RESOLUTION

R50 – 2023

Certificate of Appropriateness for work in the Historic Districts:

**Historical Architectural Review Board
COA Final Review Sheet**

**Array layout.
(Applicant)**

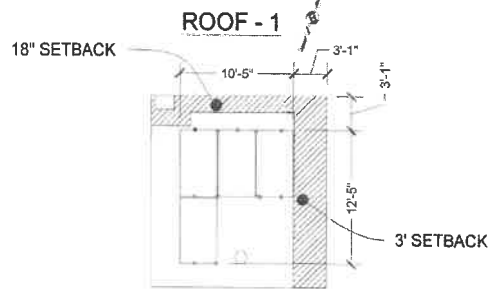
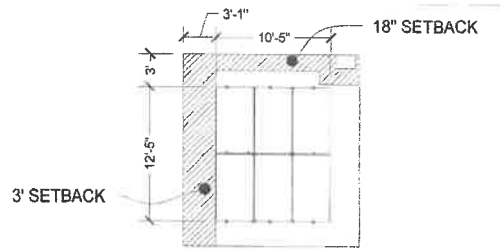
The 6-panel solar array at the front slope would have a 5'-9" setback from the front façade with a 3' setback from the side façade where the private driveway is located. The solar panels would project 6" off the roof and would likely be visible from Oak Street. Staff recommends installing a mock-up of the proposed array at this location to determine visibility. The solar panels should be inconspicuous from the public right-of-way to comply with the guidelines. Staff also suggests that the disconnect and associated utilities be moved off the front façade to a less conspicuous location, if possible.

Staff finds that the solar array proposed at the rear would not be visible from a right-of-way and complies with the guidelines.

Mr. Jordan agreed with the staff recommendation, adding that there is no guidance in the guidelines about installing solar arrays on historic slate roofs, though he noted that that is not a consideration in this application. He then commented that staff suggested moving the utilities to a secondary façade, though it was not in the actual recommendation. He asked whether the HARB would be interested in pursuing that option. Mr. Huber affirmed that the utilities should be moved but contended that the HARB cannot require that existing utilities be moved. Ms. Keller stated that the disconnect for the solar panels needs to be installed with the existing utility meter, adding that utility companies can move meters off building facades and that she could write a letter to make the request. She then clarified that the HARB cannot explicitly regulate utility meters, so if the utility company is unwilling or unable to relocate the meters, the disconnect associated with the solar panels would need to be installed on the front façade. The HARB agreed.

The HARB discussed having the applicant install a mockup for staff to review for visibility of the panel proposed for the front roof slope.

Approval, provided a mockup shows that the array on the front roof slope is inconspicuous from Oak Street, with the staff to review details, pursuant to Chapter 3, Section 3.10 Solar Energy and Energy Improvements.

Mr. Hart moved to approve with conditions the application presented on 2/6/2023 for the installation of solar panels at 735 Oak Street, as agreed to by the applicant and with the staff to review details, pursuant to Chapter 3, Section 3.10 Solar Energy and Energy Improvements, provided the utility meters are moved to a secondary façade and a mockup shows that the solar panels proposed at the front slope are inconspicuous from the right-of-way. Mr. Huber seconded the motion, which carried with unanimous support.

**Array layout.
(Applicant)**

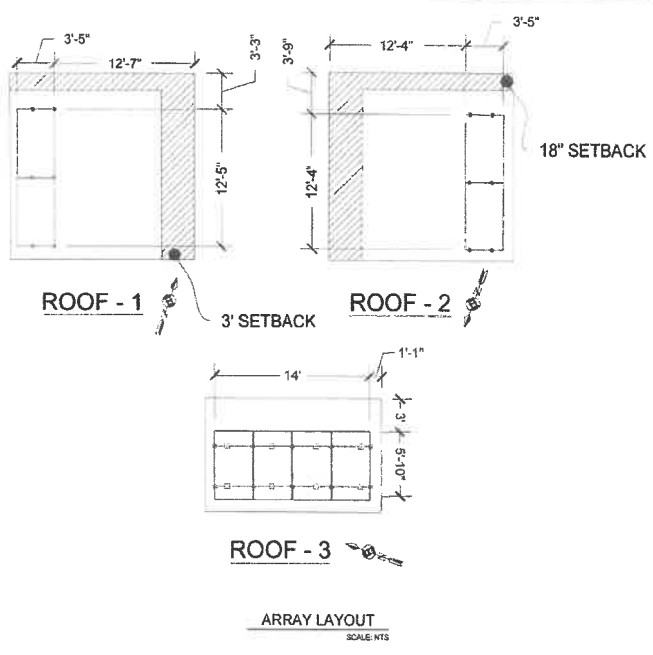
A solar panel array is proposed to be located on the west side of the dormer at the front slope and would have a 3-foot setback from the front façade. The solar panels would project 6-inches off the roof and would likely be visible from North Street. Staff recommends installing a mock-up of the proposed array at this location to determine visibility. The solar panels should be inconspicuous from the public right-of-way to comply with the guidelines.

At the rear, the property abuts Broome Street, which is a service alley that dead ends behind the building. While the solar array on the rear slope of the gable roof would be visible from the alley, this portion of the building is considered a non-contributing secondary façade and the visibility of the solar panels does not have an adverse impact on the district.

The HARB discussed whether staff can generally approve solar panels located on primary facades of properties rather than referring applications to the board. Ms. Keller noted that the design guidelines state that locating solar panels on the roof facing the street or main façade should be avoided, adding that the HARB could consider allowing staff to approve inconspicuous panels located on those facades. Mr. Jordan read a section of the guidelines that recommend minimizing visibility on pitched roofs. He noted that not all roof slopes are visible and that the HARB would remain within the guidelines to approve panels not visible from the right-of-way. He contended that the HARB seems to agree that the current application could be approved but that there may need to be further discussion on the threshold for future staff approvals.

Approval, provided a mockup shows that the array on the front roof slope is inconspicuous from North Street, with the staff to review details, pursuant to Chapter 3, Section 3.10 Solar Energy and Energy Improvements.

Mr. Hart moved to approve with conditions the application presented on 2/6/2023 for the installation of solar panels at 937 North Street, with the staff to review details, pursuant to Chapter 3, Section 3.10 Solar Energy and Energy Improvements, provided a mockup shows that the solar panels proposed at the front slope are inconspicuous from the right-of-way. Mr. Encelewski seconded the motion, which carried with unanimous support.

1550-52 W. Chew Street turret roof after work was completed. (Staff)

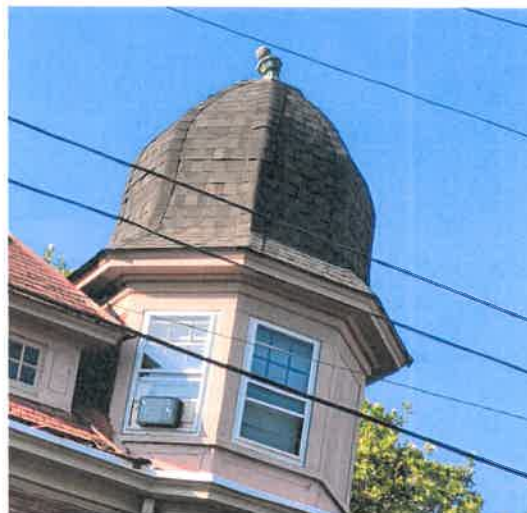
While the historic roofing material was in disrepair with displaced and missing shingles and missing sections of the decorative ridge caps, the roof should have been surveyed by a professional for the potential to repair rather than replace the entire turret roof. If complete replacement was truly necessary, the design guidelines stipulate that appropriate materials be used. In this case, a slate alternative such as a synthetic slate or an architectural shingle that replicates the dimensions, shape, profile, color, and exposure would have been more appropriate. The decorative ridge caps were a character-defining feature of the roof and should have been salvaged and reinstalled where possible, with missing sections replicated. The replacement roofing does not replicate the original roofing in material, dimension, shape, profile, color, exposure, or overall appearance. The work does not comply with the design guidelines and should not be legalized.

Mr. Hillegas argued that returning the turret roof to slate would be cost prohibitive. Mr. Huber countered that a slate alternative, such as EcoStar, could be used instead of real slate and noted that such a material is less expensive.

Mr. Hart questioned whether the HARB is still considering the previously proposed slate alternative material. Mr. Hart noted that at the last meeting where the property owner was present, the owner proposed to install Boral Inspire Classic Slate Shingles in Brick Red. Mr. Hillegas affirmed that the material could still be considered for approval. He then asked whether the ridge caps offered by the company could be installed. Mr. Huber replied that copper ridge caps that replicate the original in dimension and profile should be installed rather than the Boral ridge caps since the Boral product would not be a comparable material.

Denial, pursuant to Chapter 3, Section 3.1 Roofs. The staff recommends that a more appropriate roofing material be installed to replicate the historic roof in its dimension, shape, profile, color, exposure, and overall appearance and that the decorative ridge caps be replicated as closely as possible in material, dimension, shape, and profile.

Mr. Encelewski moved to approve with conditions the application presented on 2/6/2023 for the legalization of the turret roof at 1550-52 W. Chew Street, as agreed to by the applicant and with the staff to review details, pursuant to Chapter 3, Section 3.1 Roofs, provided Boral Inspire Classic Slate Shingles in Brick Red are used and that ridge caps matching the historic in material, dimension, and profile are installed. Mr. Huber seconded the motion, which carried with unanimous support.
